PWU INTERROGATORY #1

A-02-04-01 p. 6-7

Figure 1 - Number of Assets beyond ESL per Year Summary

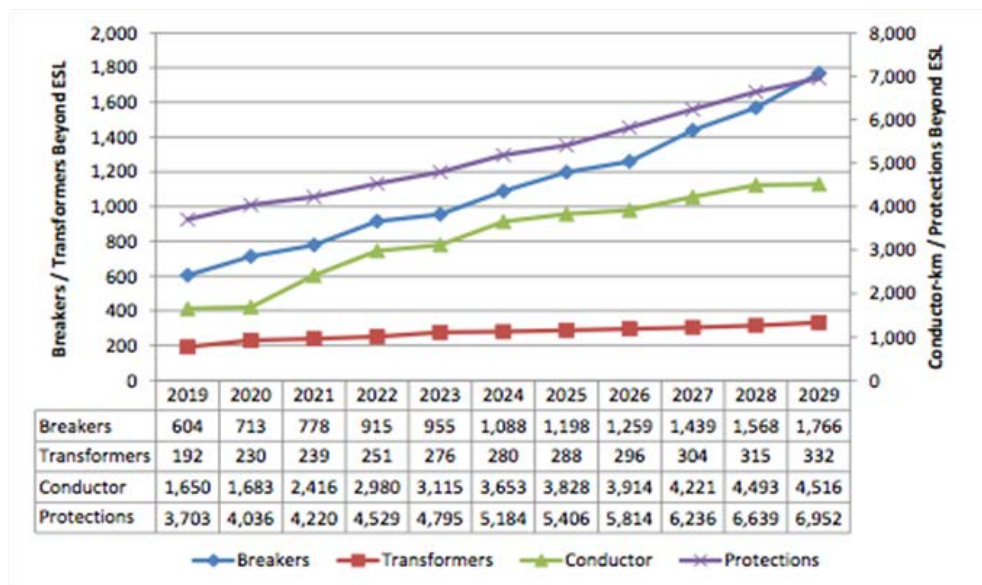
- The PWU's understanding is that the deferral of capital investments would typically create pressure on OM&A costs. Please explain how HO's proactive and strategically paced investments can prevent pressure on both OM&A and capital costs at the same time.
- Please reproduce the table in Figure 1 (for the 2019-2024 period) indicating the percentage or share that the ESL numbers represent.

b) See Table 1 below for the percentage of assets operating beyond ESL as it relates to Figure 1 from TSP Section 2.2.

Figure 10 – Number of Assets Beyond End of Service Life Per Year Summary

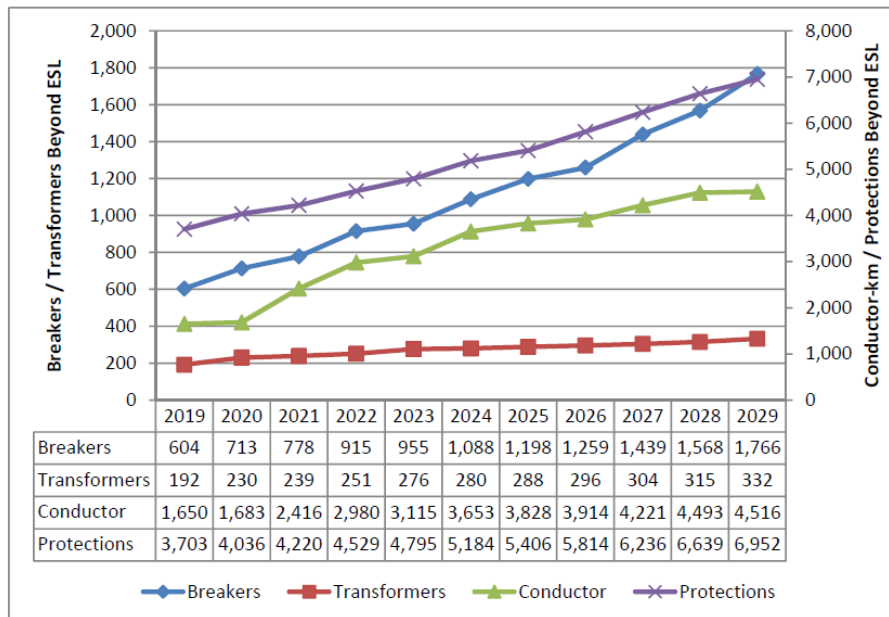
a) What is the demographic profile at the end of the rate period assuming the plan is completed?

a) See TSP Section 3.1, Figure 2 for the demographic profile of breakers, transformers, conductor, and protections following the completion of the 2020-2024 Transmission System Plan. The demographic profile following the completion of the plan over 2020-2022 is as follows:

Figure 3-2 shows the number of transformers by vintage.

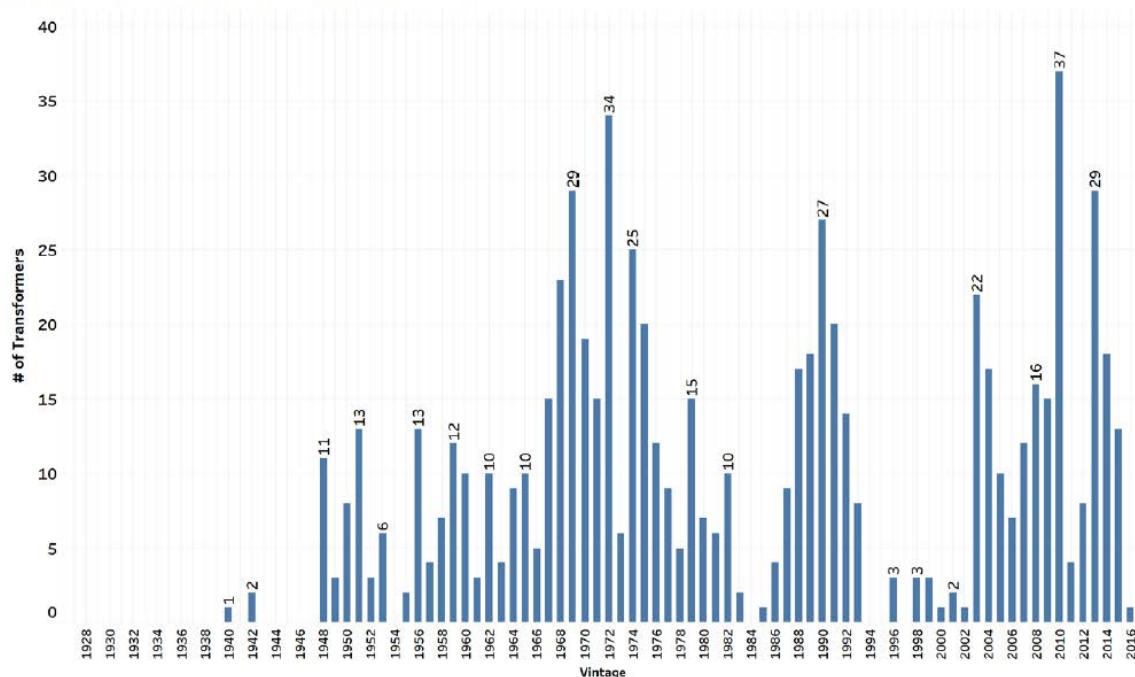
a) What will this chart look like at the end of the test period?

a) The number of transformers with high condition risk factors from the 1970's and earlier vintages, is higher than ones built after 1970. After planned removal of these high condition risk factor transformers, the spikes on the chart prior to the 1970's will be smoothed out.

Figure 4-6 shows long-term and short-term risk for Hydro One's 230 kV units using the five-category ranking.

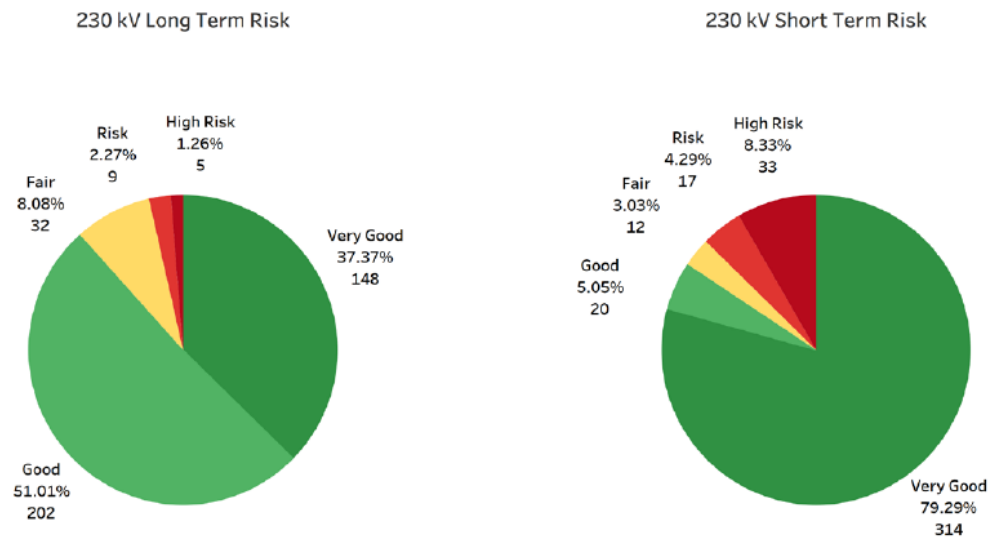
- a) What does “short term” and “long term” mean in this context?
- b) Please define “high-risk”. Is it a measure of the probability of failure? If so, what is the threshold?

- a) Please refer to Interrogatory I-05-CME-18.
- b) High risk means there are signs of internal transformer problems that require a timely response. If confirmed by further testing, consideration will be given to remove the unit from service.
